BZA Application Form

BZA Number: 201432

LOCATION OF PROPERTY: 1640 Massachusetts Ave, Cambridge, MA

BZA 1640 Mass Ave
Thursday, December 15, 2022

2nd Floor Plan Proposed
= 1'-0"

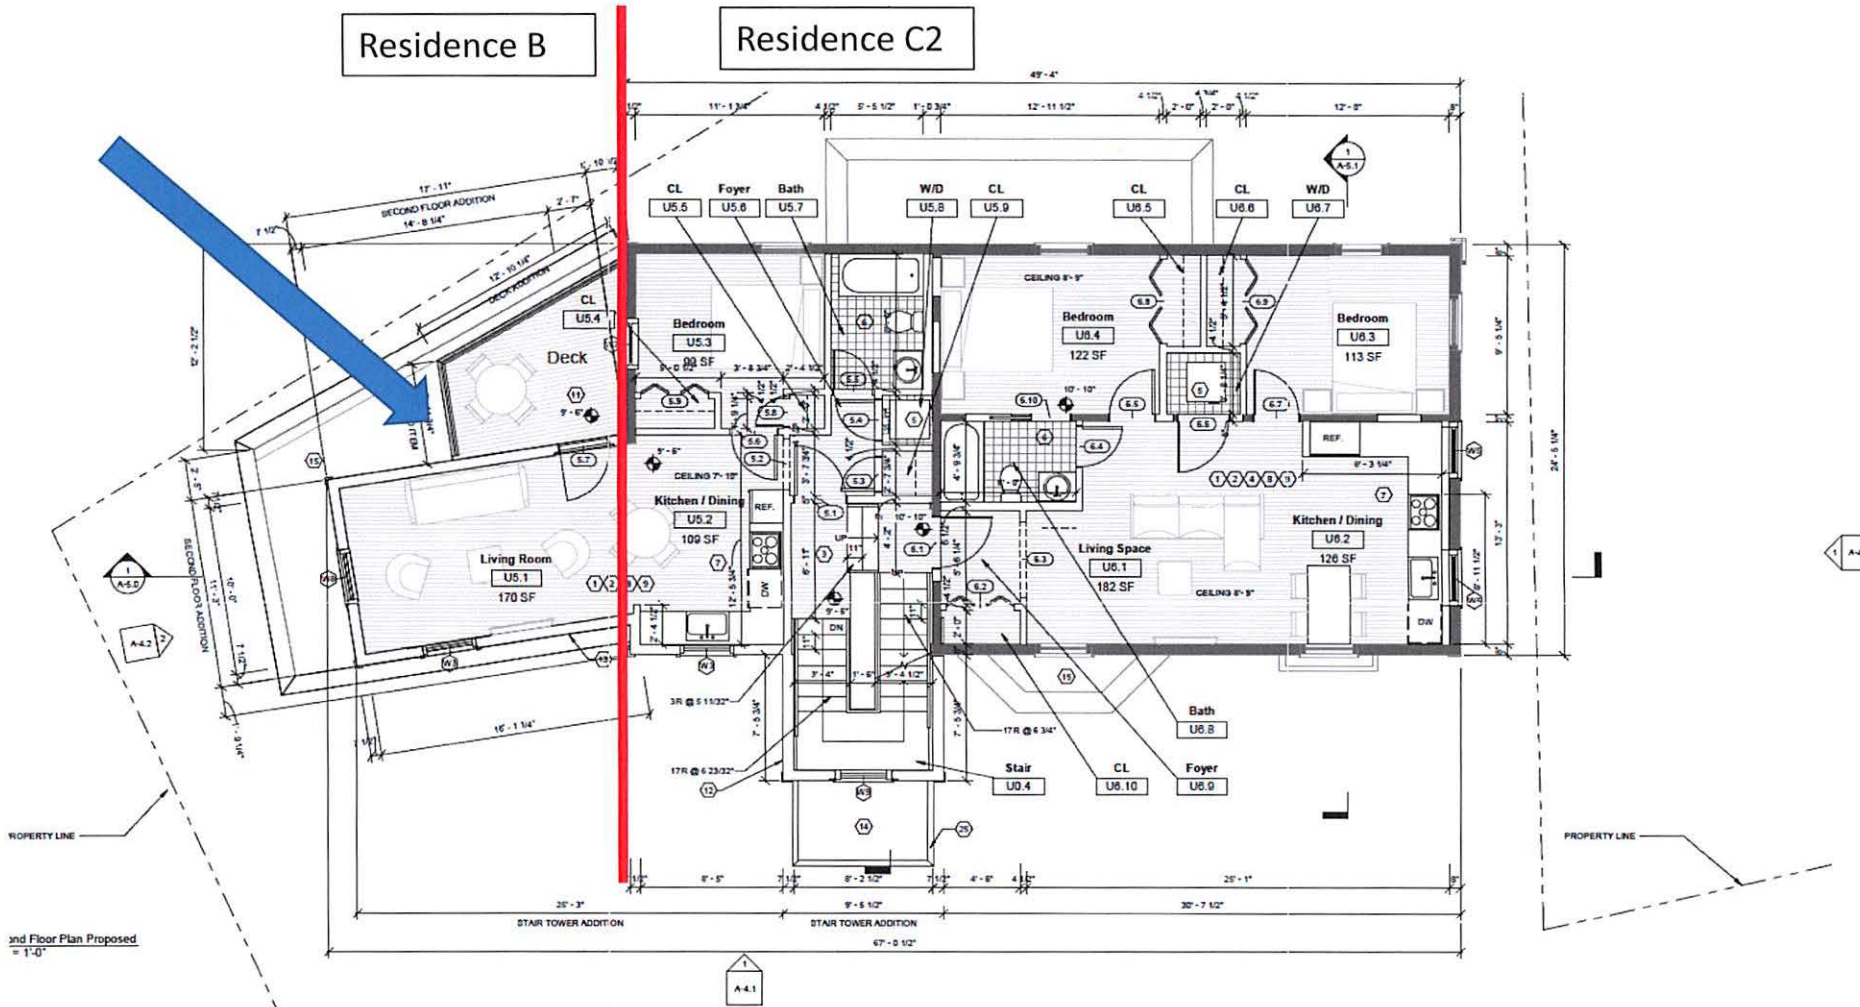
Abutter's objections to the variances are only those requested for the second floor addition and roof deck. We are directly affected.

Hardship for abutters from Floor 2 addition and attached deck.

1. By adding a second bedroom, they are increasing the garbage going outside and worsening the rat problem they have proven to create and they have no plan for how garbage collection and storage will meet state code

4. Density → more tenants → more garbage → more rats → neighborhood health problems.

- Deny the petitioner's variance request (1) for the non-complying second floor addition and the roof deck.
- If 1 is denied, accept their petition for the variance (2) for density relief. Our major objections on density as an abutter will have been eliminated.
- If Variance 1 is accepted, deny variance 2 on grounds of density inconsistent with Ordinance section 1.3 (Purpose)
- Reject the permitting request to extend Residence C2 into the current B on the basis that this privilege is not used and creates a taking of our rights under Residence B and eliminates the chance to review any future proposal at the time and under the terms when it is made.
- Make acceptance of other variances or permits contingent on acceptable rat-proof garbage management and placement of air conditioning equipment so that it is not a hardship to us.

Their proposed living room window

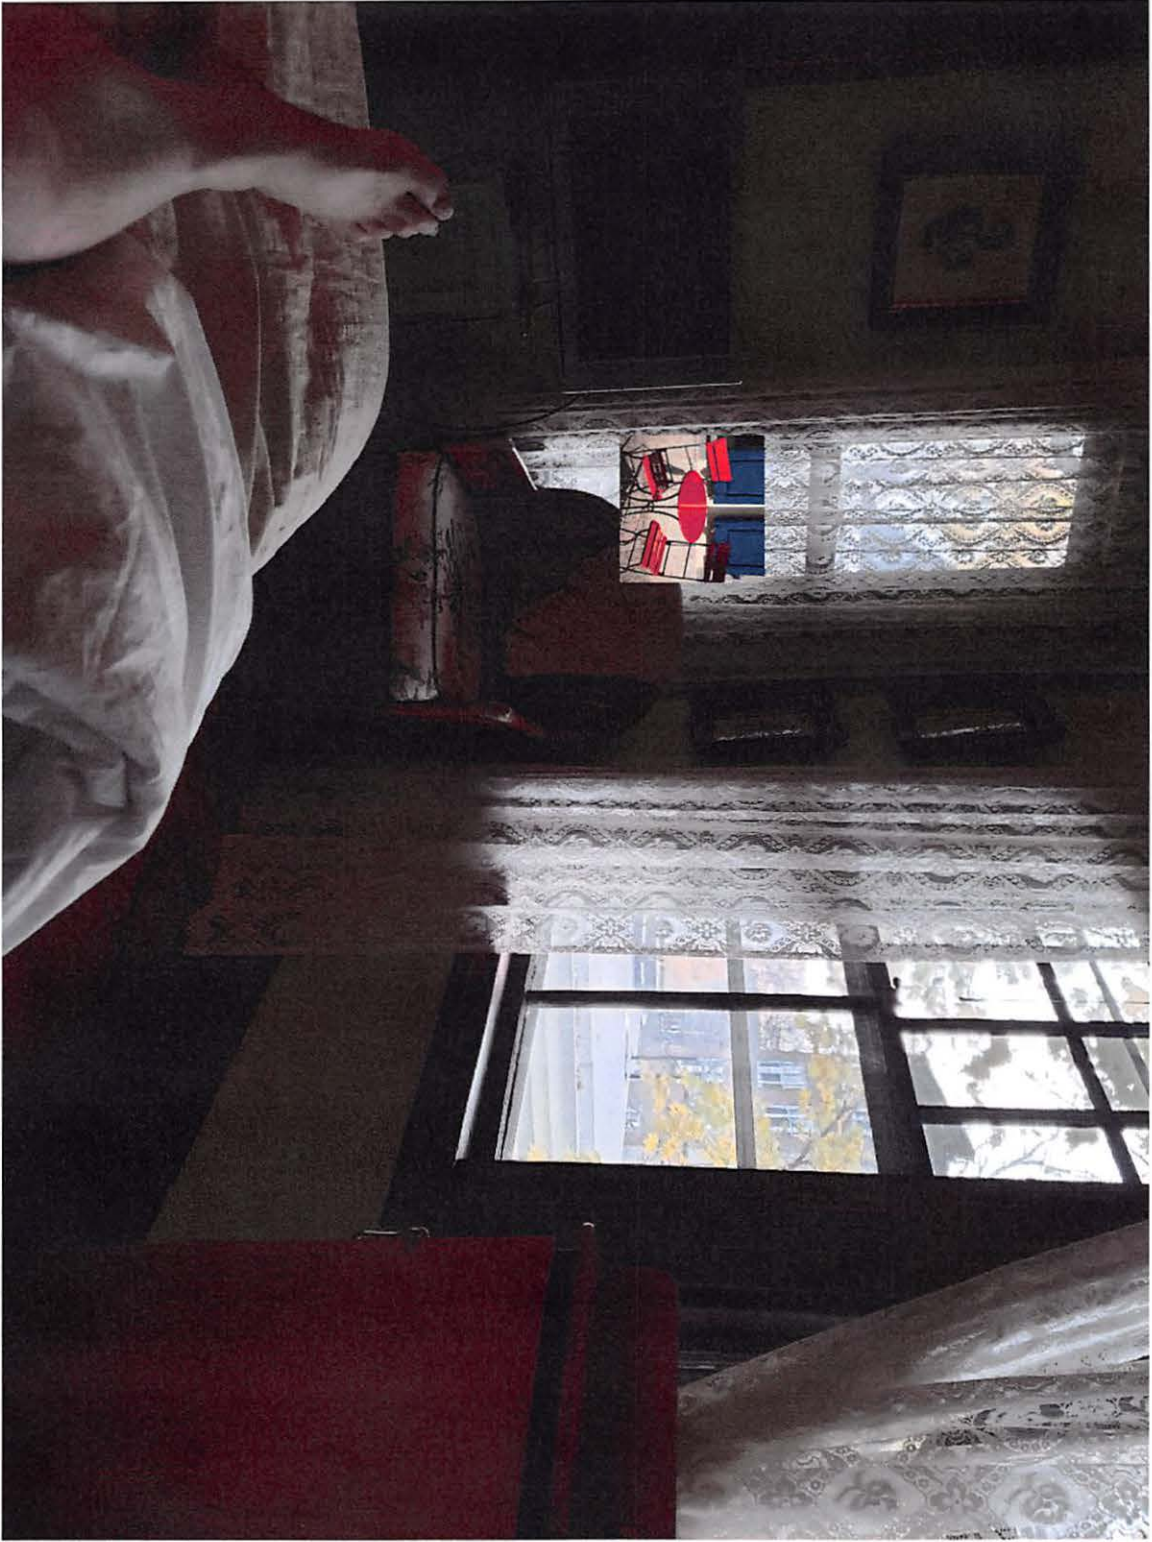
Variance category 2: Density relief in Residence B

If the setback variances are awarded, then we extend our claims of hardship to Variance 2 (density). The negative effects on us caused by their expanding into the Residence B zone are the same as for the variances. These effects are the result of increasing project density. Changing the triangle of Residence B to C2 by permit doesn't change the deleterious effects on us and seems to us to negatively influence and subvert the general purpose of the City codes regarding density.
